<p><b>EXHIBIT NO. 10</b></p> <p><b>APPLICATION NO.</b> A-1-MEN-10-015</p> <p><b>BETHEL &amp; HUPP</b></p> <p><b>VEGETATION SIMULATIONS OF</b> <b>VEGETATION SCREENING</b> <b>SUBMITTED BY AGENT (1 of 10)</b></p>
---

EXHIBIT NO. 11  
 APPLICATION NO.  
 A-1-MEN-10-015  
 BETHEL & HUPP  
 APPLICANT'S ANALYSIS OF  
 GLAZING AUTHORIZED BY  
 CDPM 98-01(05) (1 of 14)

RE: A-1-MEN-10-015 (Bethel/Hupp) –Entry Courtyard Glazing approved in CDPM #98-01(05)  
9490 North Highway One  
Mendocino, CA 95460  
APN 119-320-04-00

Staff's Analysis of Grading  
Authorized by CDM  
98-01(05)  
No. A-1-MEN-10-015  
(Bethel & Hupp)  
1 of 7

Exhibit 1: CDPM #98-01(05) Staff  
Report Exhibit C - Floor Plan

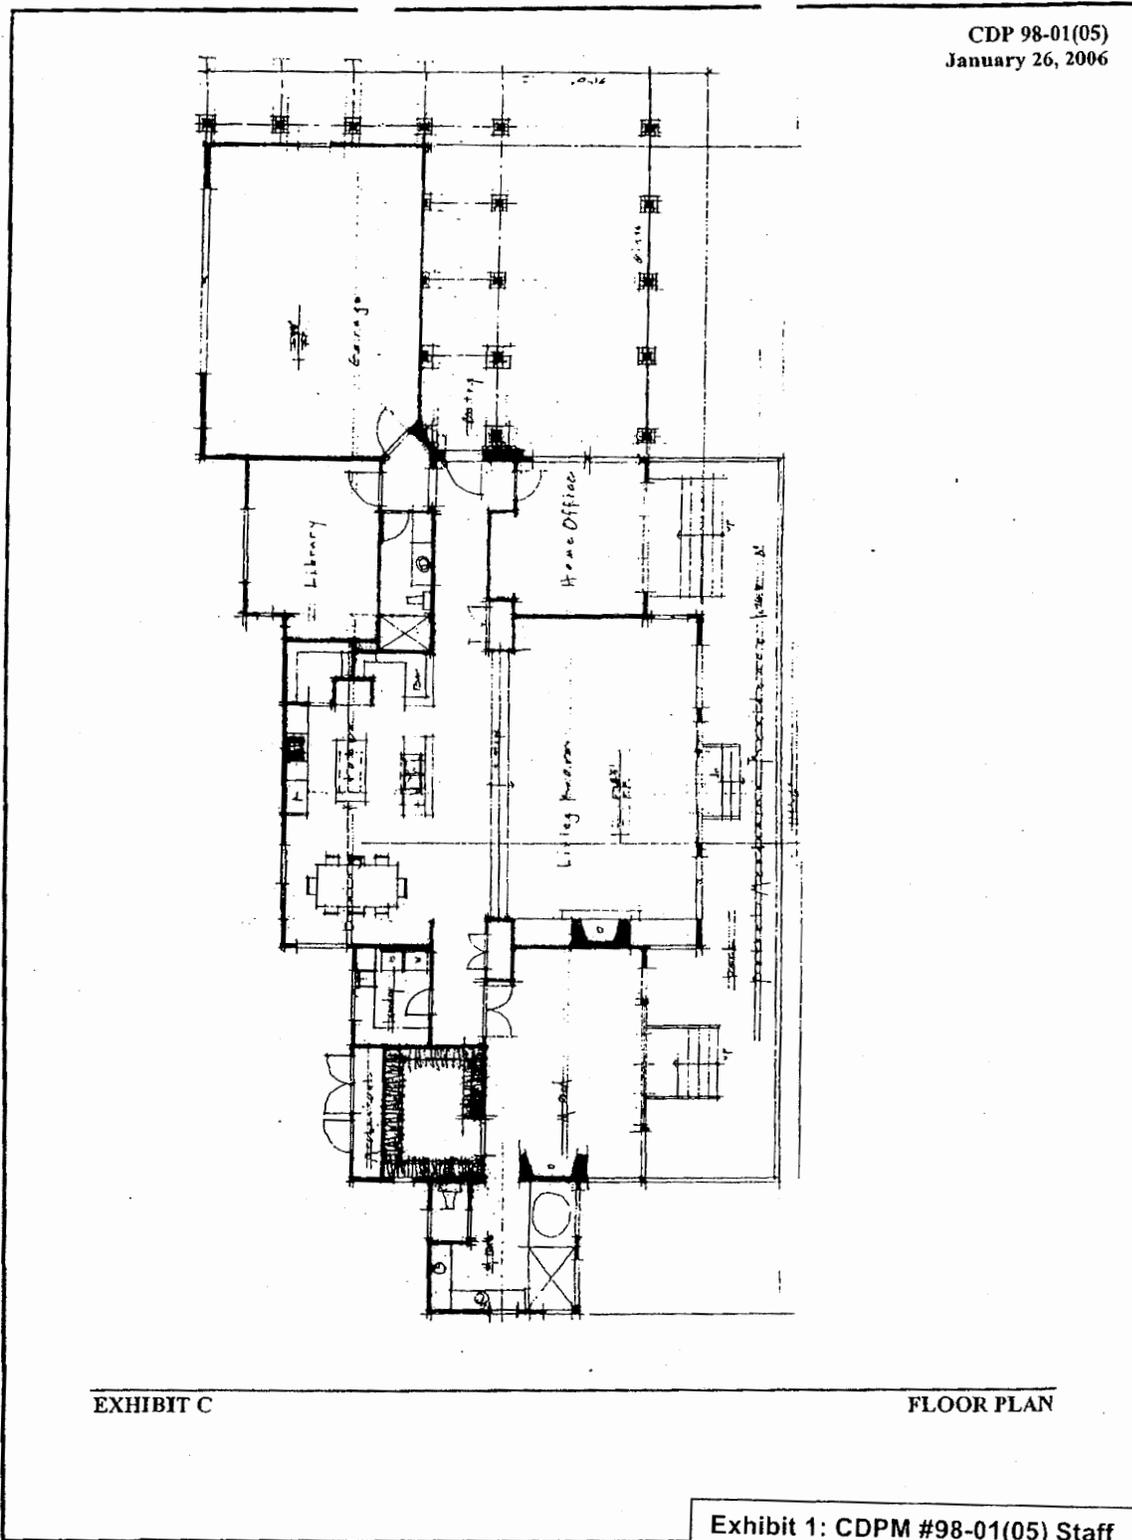
In particular, Abbey discovered that Staff Report Exhibit C – Floor Plan – (see this letter's **Exhibit 1**) does not match Staff Report Exhibit B – Site Plan – (see this letter's **Exhibit 2**) relative to the Entry Courtyard into the residence. This is because Planning Staff mistakenly neglected to replace Staff Report Exhibit C with the Project Team's revised Floor Plan for the residence.

According to the Project Architect of the time, Leonard Grant, there was never any intent to remove the courtyard glazing (noted as "Glass" on the Staff Report's Exhibit C; **Exhibit 1**). Per Mr. Grant's July 9, 2012 letter (original enclosed; **Exhibit 5**),

Unfortunately, for clarification sake, a superseded floor plan was included as Exhibit C of the CDPM 98-2001(2005) staff report.

Exhibit C is the 2005 originally proposed floor plan, which illustrates three rows of posts that extend from the corner of the residence south to the end of what may be considered a breezeway or entryway located west of the garage. The furthest row of posts from the house (third row) is noted to be connected by glass. A grading plan was associated with the originally proposed 2005 modification and also illustrates the three rows of posts. The local file contains both the 2005 original floor plan and grading plan, both are noted as "superseded."

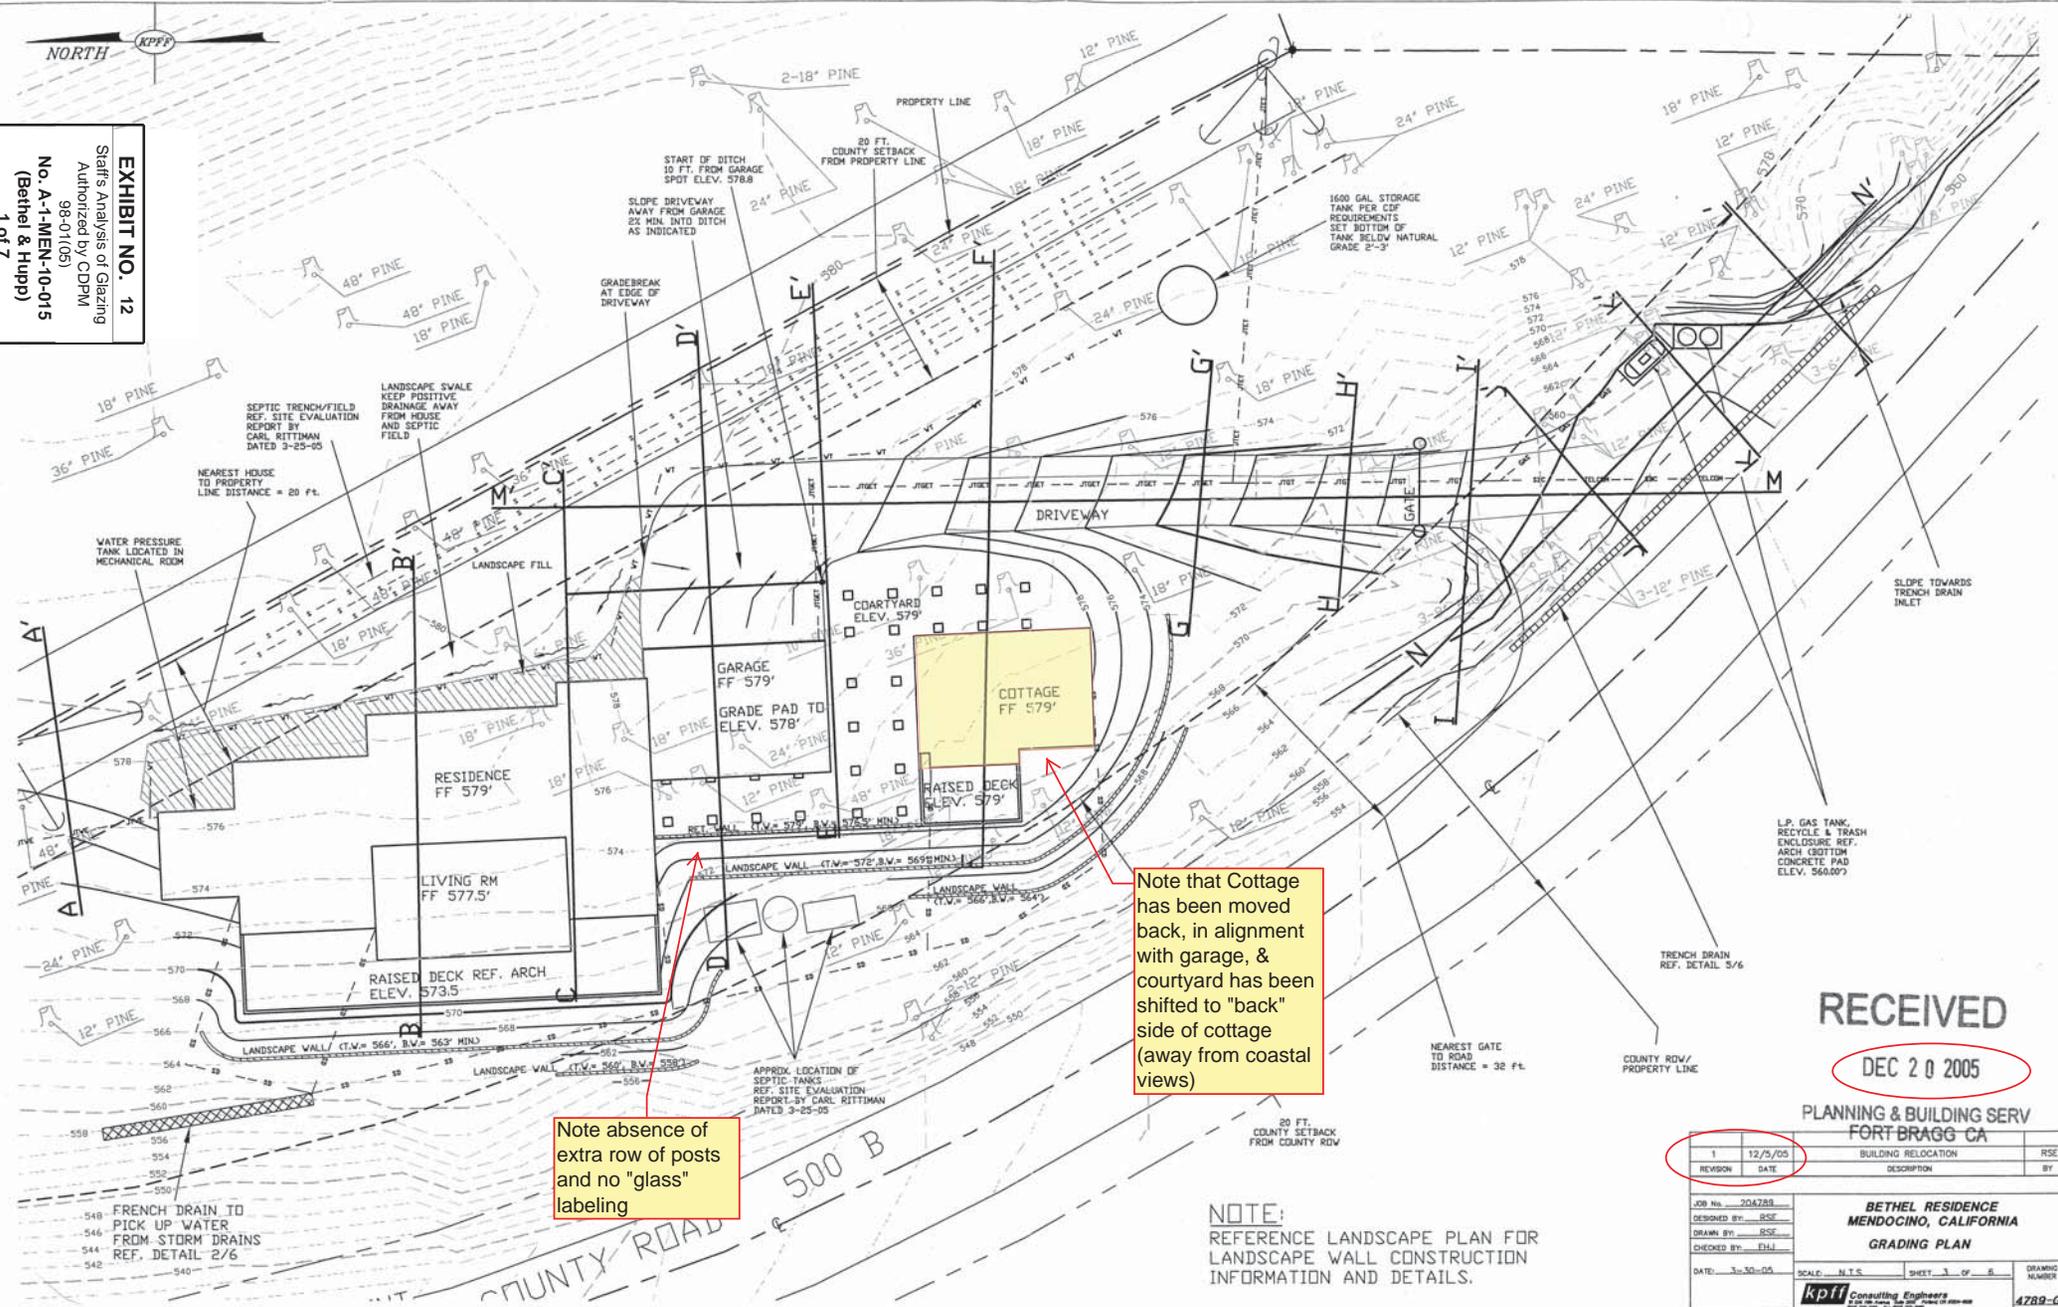
Note absence of extra row of posts and no "glass" labeling

Note that Cottage has been moved back, in alignment with garage, & courtyard has been shifted to "back" side of cottage (away from coastal views)

(2 of 7)

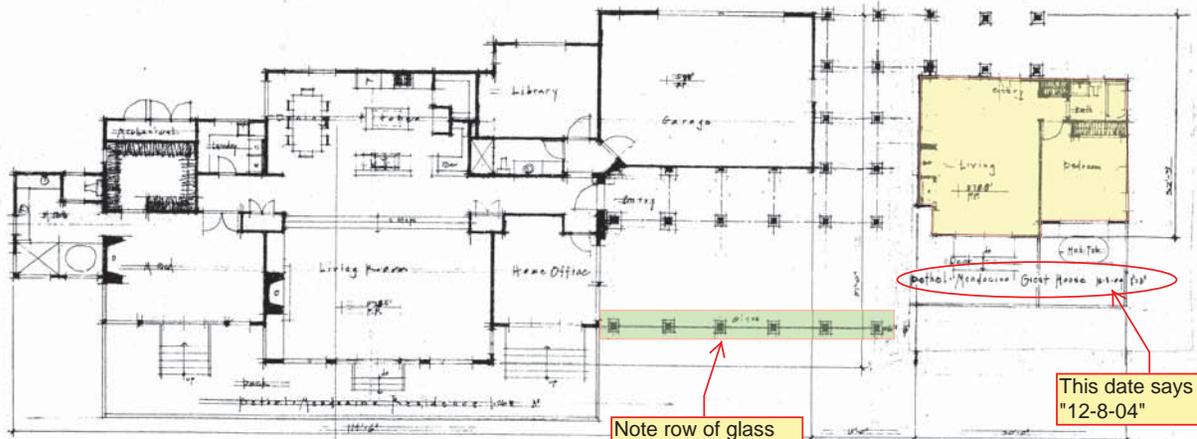
Note row of glass between posts that applicant says was authorized

Exhibit 5 - BB3 From Village

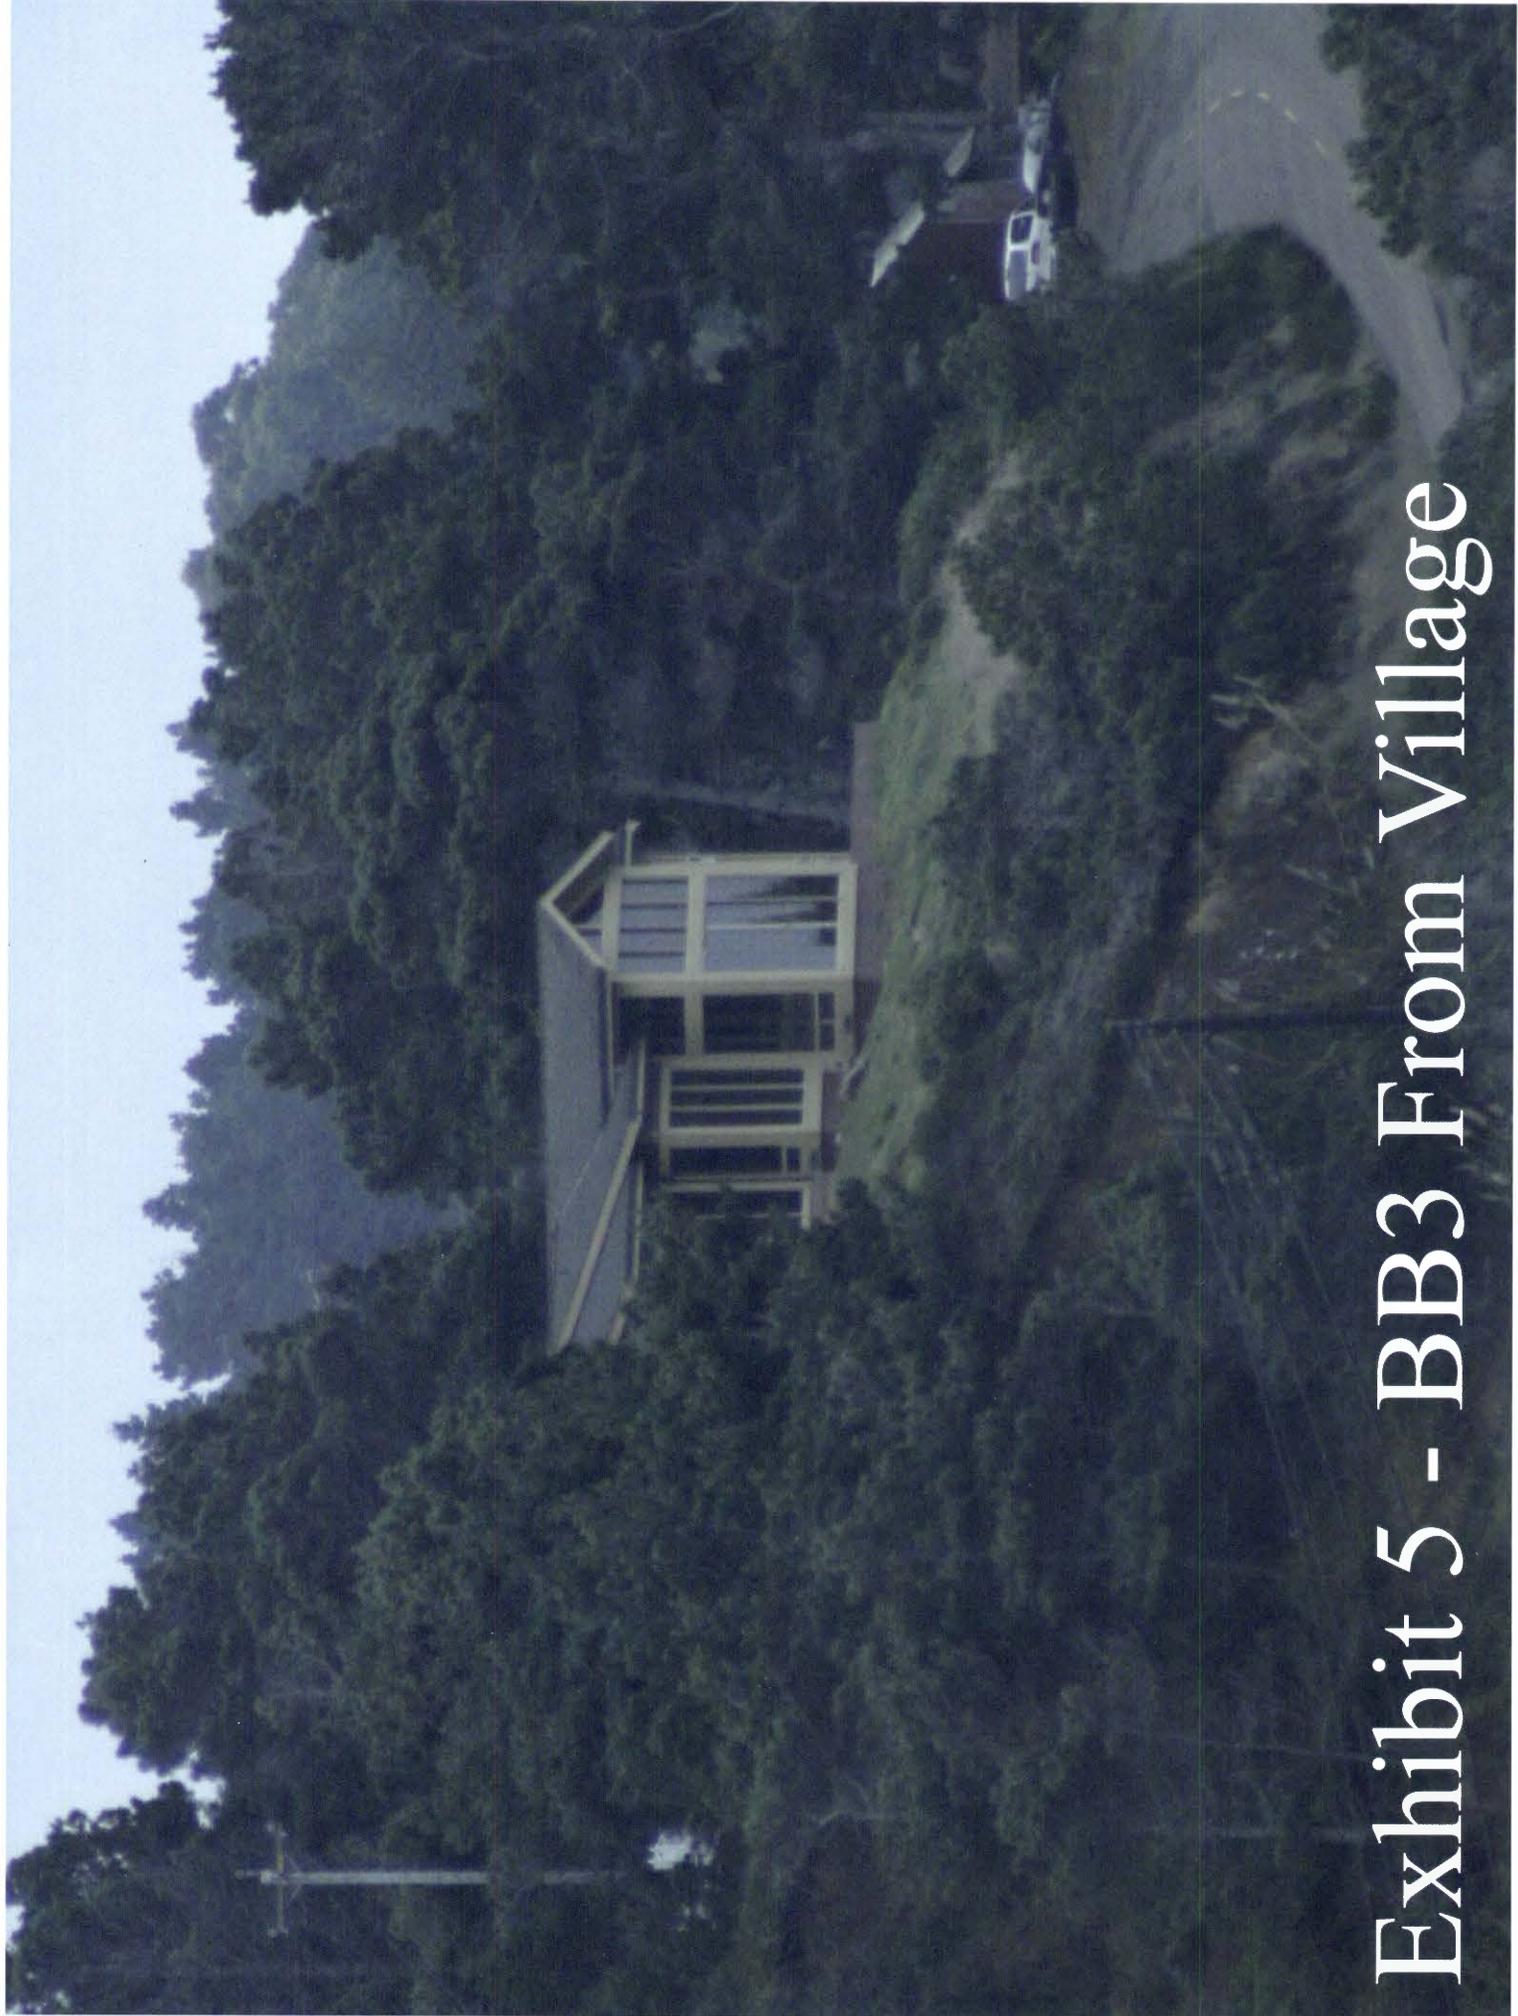
2. If any modification is required, the most effective change would be to paint the west face of the trim brown to match the stain color. In studying the photos submitted in **Exhibit 5**, as well as the photos previously submitted by Ms Wynn, it is the light color of the siding trim which draws one's attention to the house. If this were painted brown, the eye would not be drawn to the structure.

BB1 FLOORPLAN OUTLINE

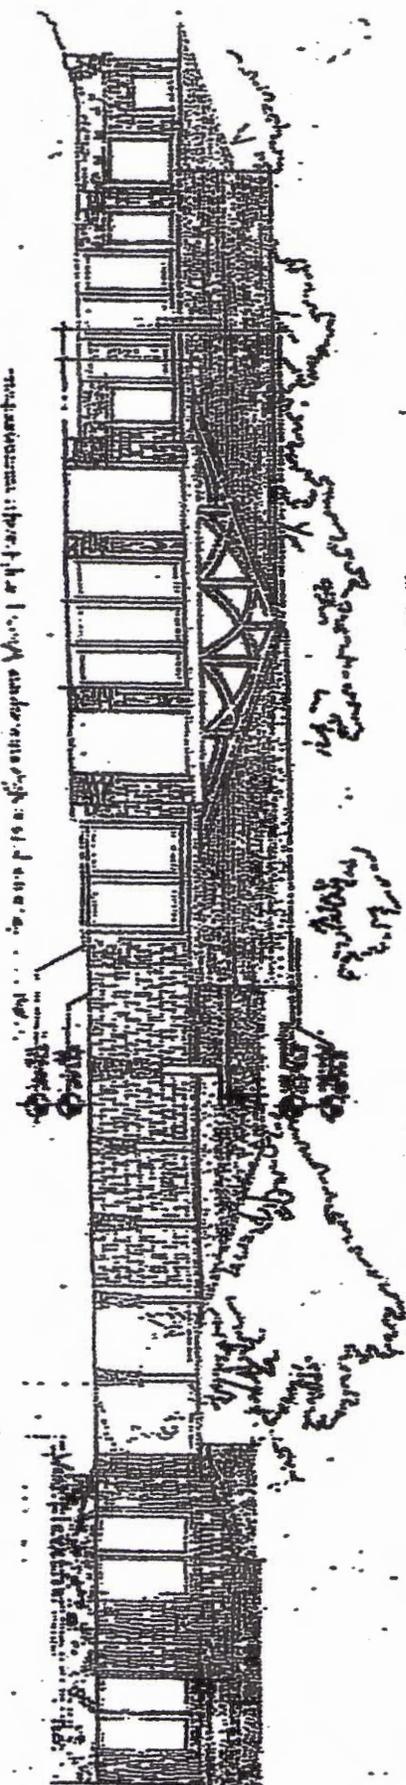
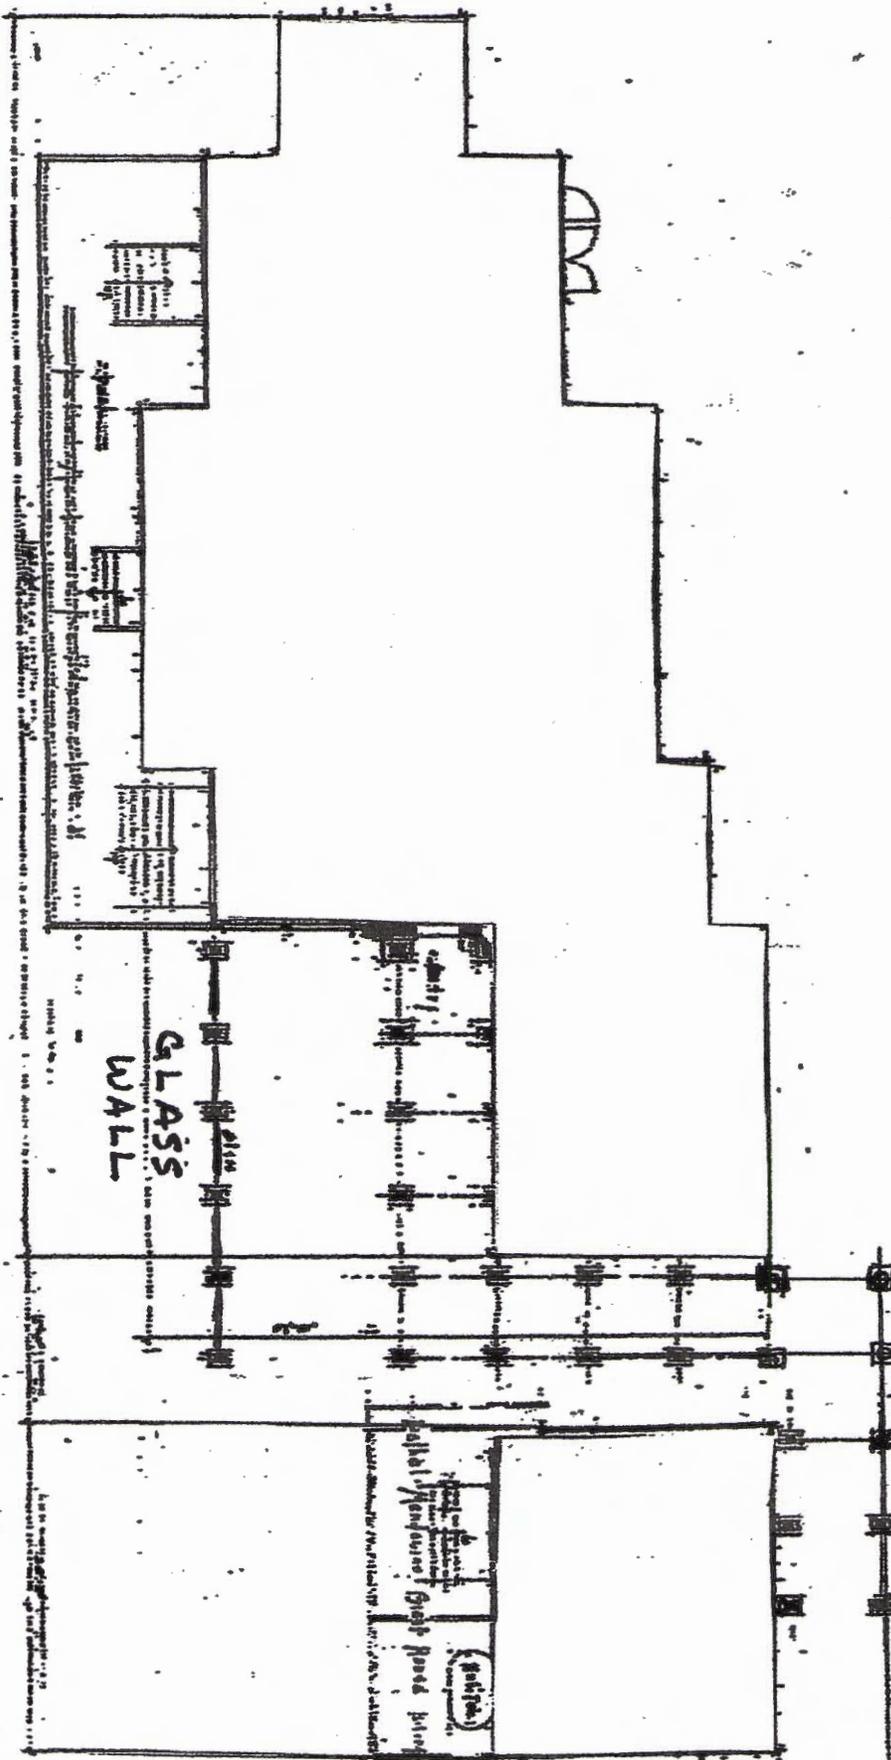
**EXHIBIT 6** is an overlay of the BB1 floor plan superimposed on the BB3 floor plan. Ms Wynn previously submitted the yellow colored BB3/BB1 comparison to show how the rooms of BB1 were rearranged into BB2/3.
